SUBJECT: SAN ONOFRE NUCLEAR GENERATING STATION, UNITS 2 AND 3 -
ISSUANCE OF AMENDMENTS RE: PRESSURE TEMPERATURE LIMITS
(TAC NOS. MA8882 and MA8883)

Amendment No. 172

Amendment No. 163
License No. NPF-15

SAFETY EVALUATION BY THE OFFICE OF NUCLEAR REACTOR REGULATION
RELATED TO AMENDMENT NO. 172 TO FACILITY OPERATING LICENSE NO. NPF-10
AND AMENDMENT NO. 163 TO FACILITY OPERATING LICENSE NO. NPF-15

Figure 3.4.3-1

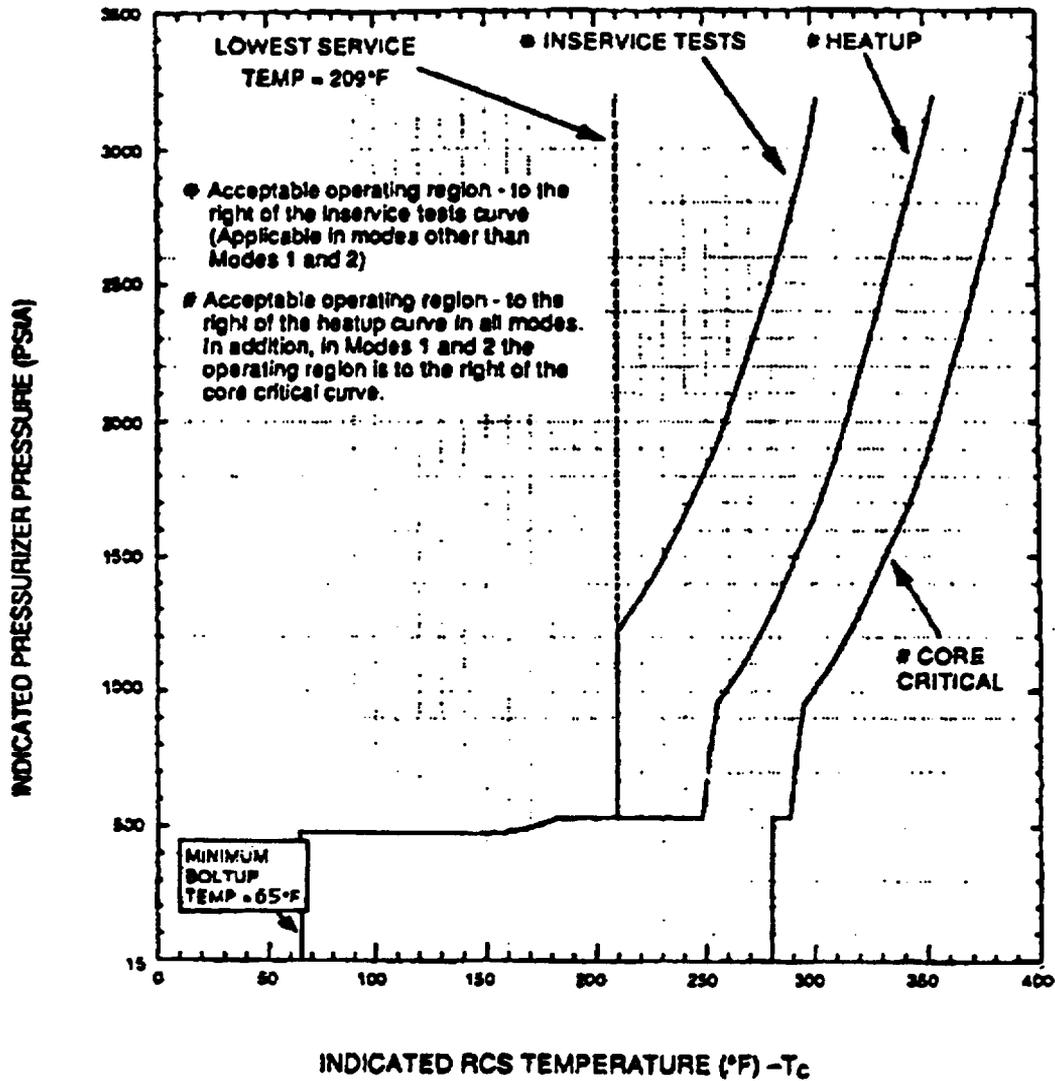
LCO 3.4.3 With the reactor vessel head bolts tensioned*, the Reactor Coolant System (except the pressurizer) temperature and pressure shall be limited in accordance with the limit lines shown on Figures 3.4.3-1, 3.4.3-2, 3.4.3-3, 3.4.3-4, 3.4.3-5, and Table 3.4.3-1 during heatup, cooldown, and inservice leak and hydrostatic testing with:

- a. A maximum heatup of 60°F in any 1-hour period with RCS cold leg temperature greater than or equal to 65°F.
- b. A maximum cooldown as specified by Figure 3.4.3-3 in any 1-hour period with RCS cold leg temperature less than or equal to 160°F. A maximum cooldown of 100°F in any 1-hour period with RCS cold leg temperature greater than 160°F.
- c. A maximum temperature change of 10°F in any 1-hour period during inservice hydrostatic and leak testing operations above the heatup and cooldown limit curves.
- d. A minimum temperature of 65°F to tension reactor vessel head bolts.

The SONGS P-T limits have a unique shape in the low temperature region (65 °F to 126 °F) for both heatup and cooldown. For cooldown P-T limits (cooldown curves), when the pressure drops to 450 psig, the cooldown curves continue to cool at a constant pressure and extend horizontally to the minimum temperature line (the vertical line determined by the boltup temperature). This unique shape would be nonconservative for the cooldown curves based on a constant cooldown rate. However, in validating the proposed cooldown curves, the staff found that these curves were developed for varying cooldown rates. Consequently, the cooldown curve of each SONGS unit is accompanied by a separate cooldown rate curve, which shows the variation of the cooldown rate with the temperature of the coolant. To further validate the revised part of the cooldown curves, the staff used the ART of 129 °F at 1/4T for the lower shell plate C-6404-5 (the limiting beltline material) for Unit 2 and the ART of 116 °F at 1/4T for the intermediate shell plate C-6802-1 for Unit 3 from the licensee's submittal for the current P-T limits and applied the 1989 ASME Appendix G methodology to generate the cooldown curves for temperatures less than 126 °F for both units. The staff's results indicated that the licensee's cooldown curves in the low temperature region are in compliance with the 1989 ASME Appendix G requirements. Since the 1989 ASME Appendix G methodology is more conservative than the 1995 (the 1996 Addenda) ASME Appendix G methodology, currently endorsed by the NRC for P-T limits application, using the 1989 ASME Appendix G methodology is acceptable.

Unlike the cooldown curves, the licensee developed the heatup P-T limits (heatup curves) based on a constant heatup rate of 60 °F/Hour. In the beginning of heatup, the pressure is maintained constant at 497 psig for Unit 2 and 515 psig for Unit 3 until the coolant temperature

has reached 126 °F. This unique shape would be nonconservative for the heatup curves based on a constant through-wall temperature difference. However, in validating the proposed heatup curves, the staff found that they were developed for the actual through-wall temperature difference using an axisymmetric finite element model (including cladding). This approach took advantage of the transient state of the early heatup, which has a much smaller through-wall temperature difference, and hence a much smaller thermal stress intensity factor for the assumed flaw at 3/4T. Consequently, the pressure at 65 °F could be as high as the pressure at 126 °F where the through-wall temperature difference has reached about 80 percent of the steady-state value. Although the 1989 ASME Appendix G methodology does not specify how the through-wall temperature difference should be obtained, the 1995 ASME Appendix G methodology specifies an option for the thermal stress intensity factor to be calculated from "the thermal stress distribution at any specified time during the heatup or cooldown." Hence, the licensee's methodology for generating heatup curves based on the through-wall temperature difference at any specified time during the heatup is equivalent to the 1995 ASME Appendix G methodology. Considering the above, the staff confirmed that the licensee's heatup curves in the low temperature region are in compliance with both the 1989 and the 1995 ASME Appendix G requirements.

FIGURE 3.4.3-2

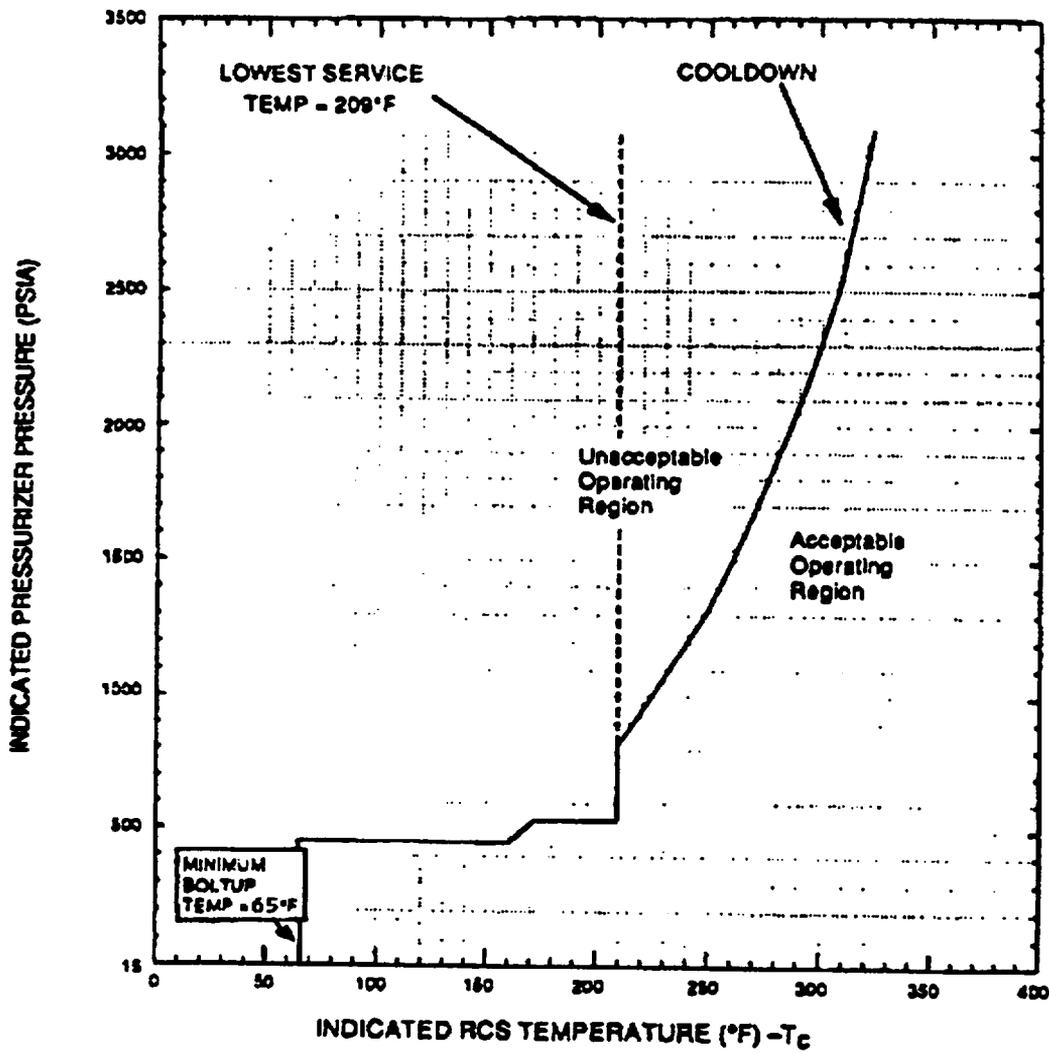
NOTE: A MAXIMUM COOLDOWN RATE OF 100°F/HR IS ALLOWED
AT ANY TEMPERATURE ABOVE 160°F

FIGURE 3.4.3-4

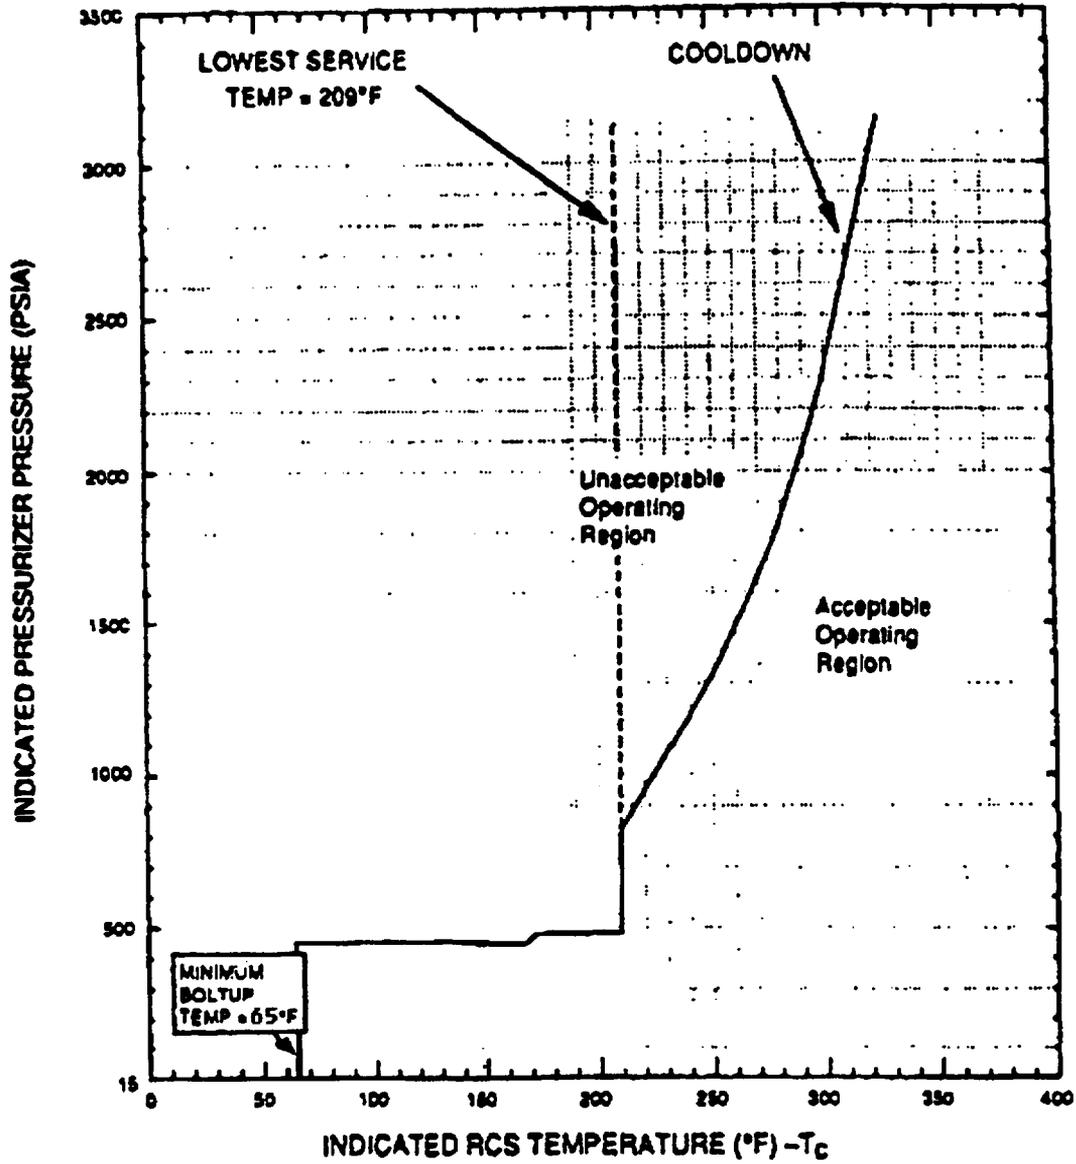
NOTE: A MAXIMUM COOLDOWN RATE OF 100°F/HR IS ALLOWED
AT ANY TEMPERATURE ABOVE 168°F

FIGURE 3.4.3-1

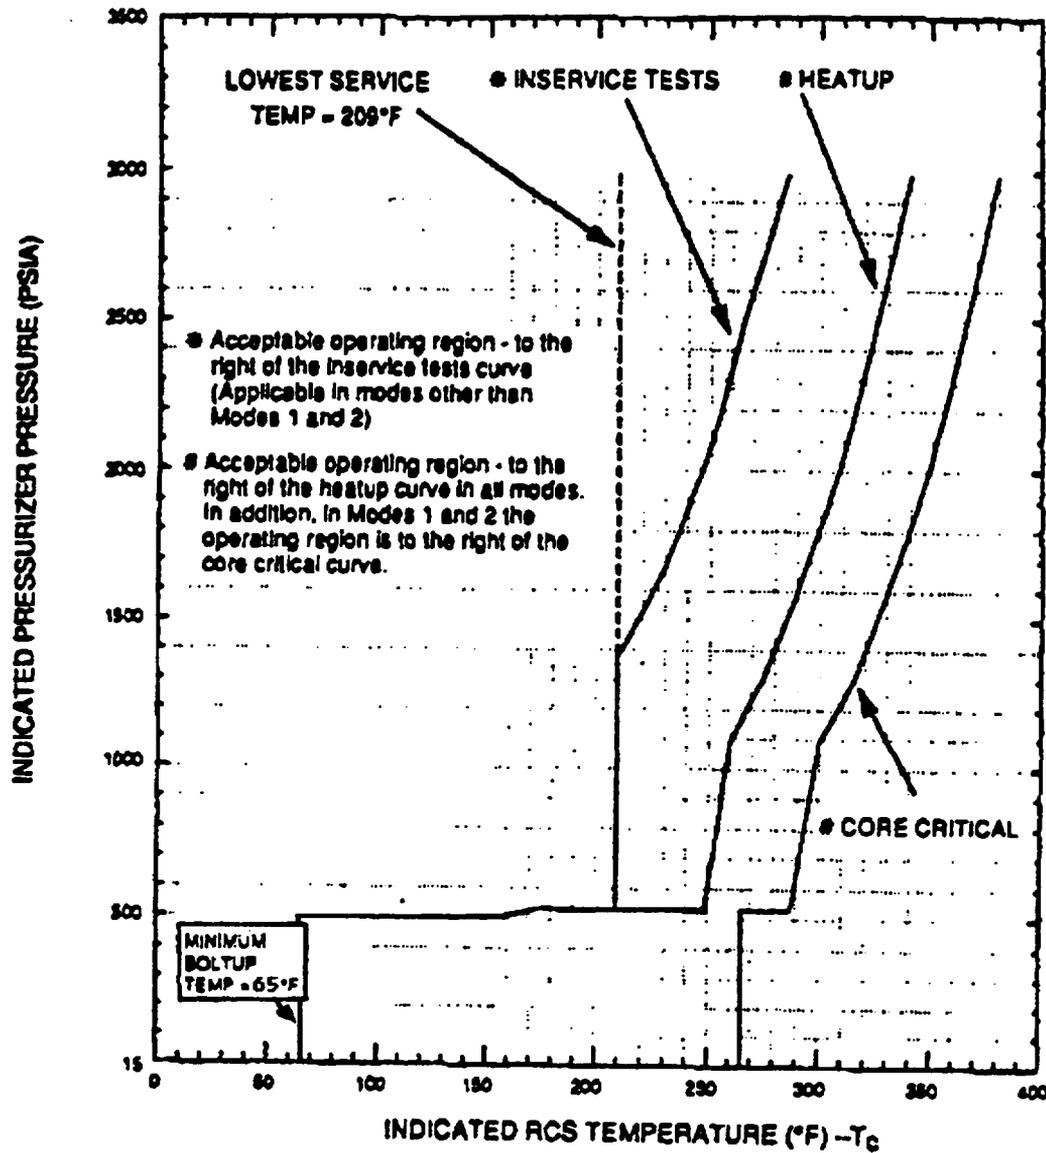
- LCO 3.4.3 With the reactor vessel head bolts tensioned*, the Reactor Coolant System (except the pressurizer) temperature and pressure shall be limited in accordance with the limit lines shown on Figures 3.4.3-1, 3.4.3-2, 3.4.3-3, 3.4.3-4, 3.4.3-5, and Table 3.4.3-1 during heatup, cooldown, and inservice leak and hydrostatic testing with:

- a. A maximum heatup of 60°F in any 1-hour period with RCS cold leg temperature greater than or equal to 65°F.
 - b. A maximum cooldown as specified by Figure 3.4.3-3 in any 1-hour period with RCS cold leg temperature less than or equal to 147°F. A maximum cooldown of 100°F in any 1-hour period with RCS cold leg temperature greater than 147°F.

FIGURE 3.4.3-2

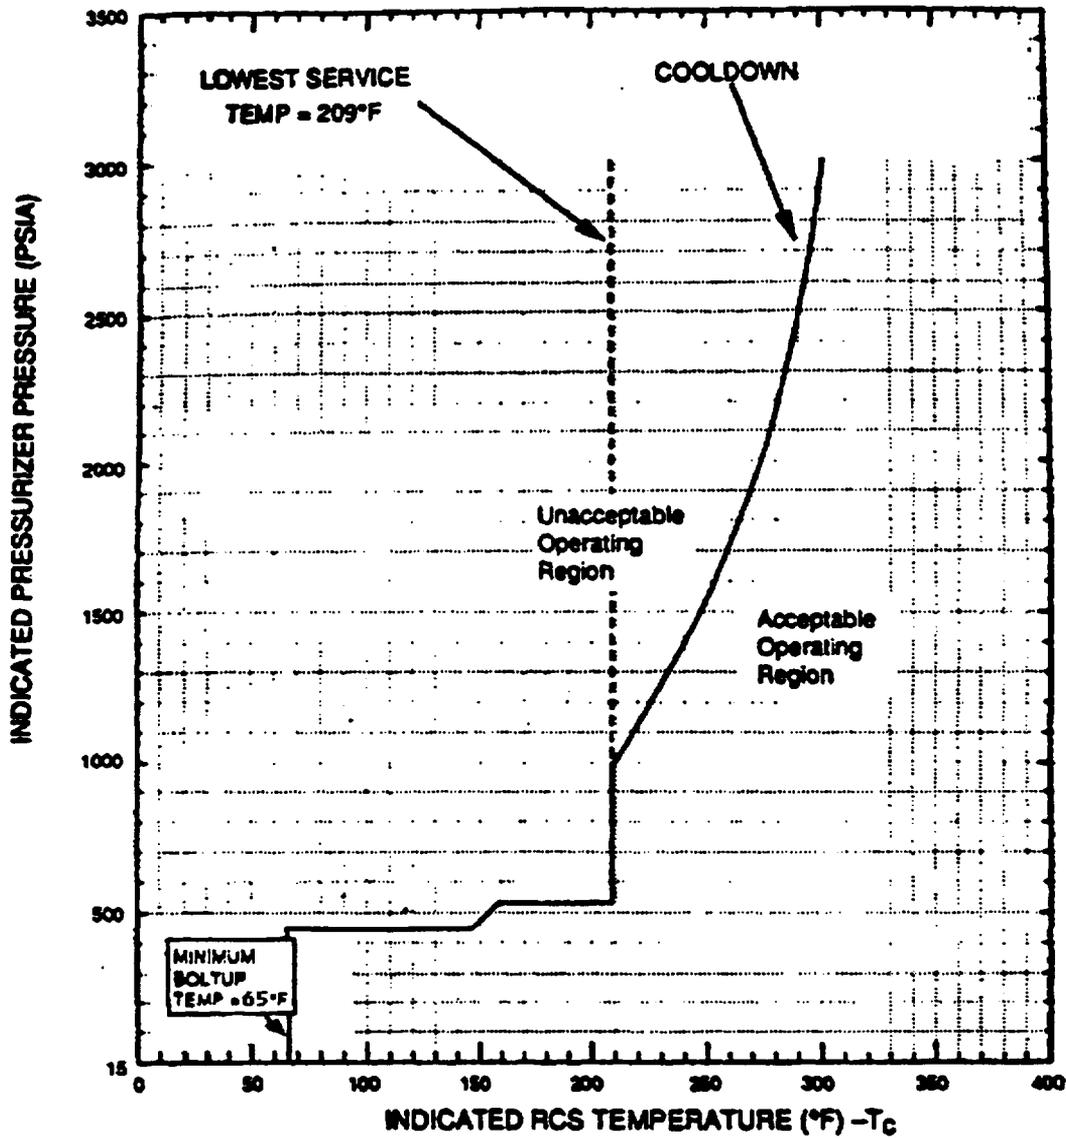
NOTE: A MAXIMUM COOLDOWN RATE OF 100°F/HR IS ALLOWED
AT ANY TEMPERATURE ABOVE 147°F

FIGURE 3.4.3-4

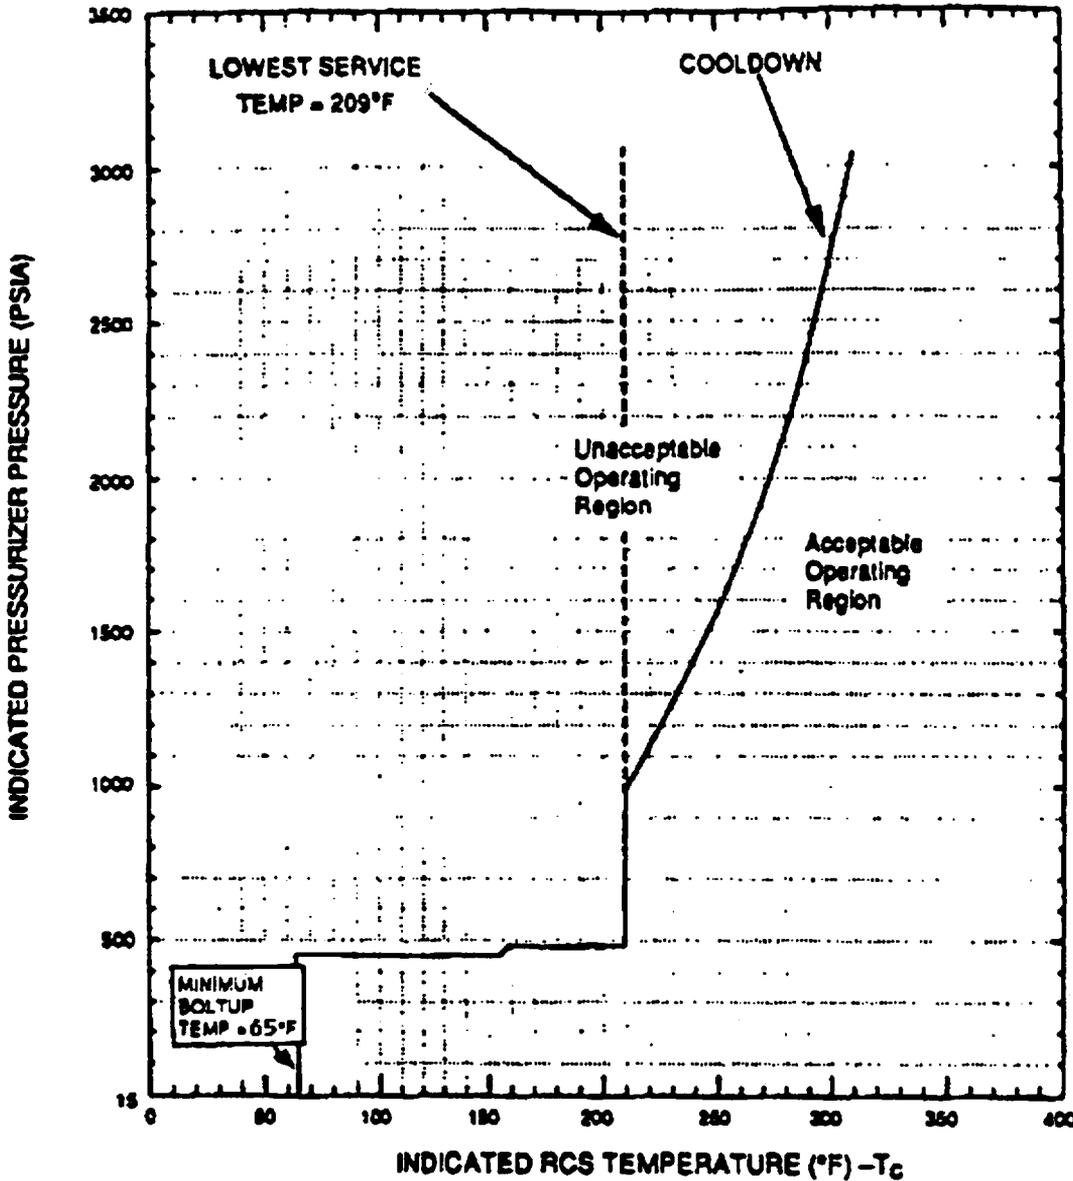
NOTE: A MAXIMUM COOLDOWN RATE OF 100°F/HR IS ALLOWED
AT ANY TEMPERATURE ABOVE 155°F
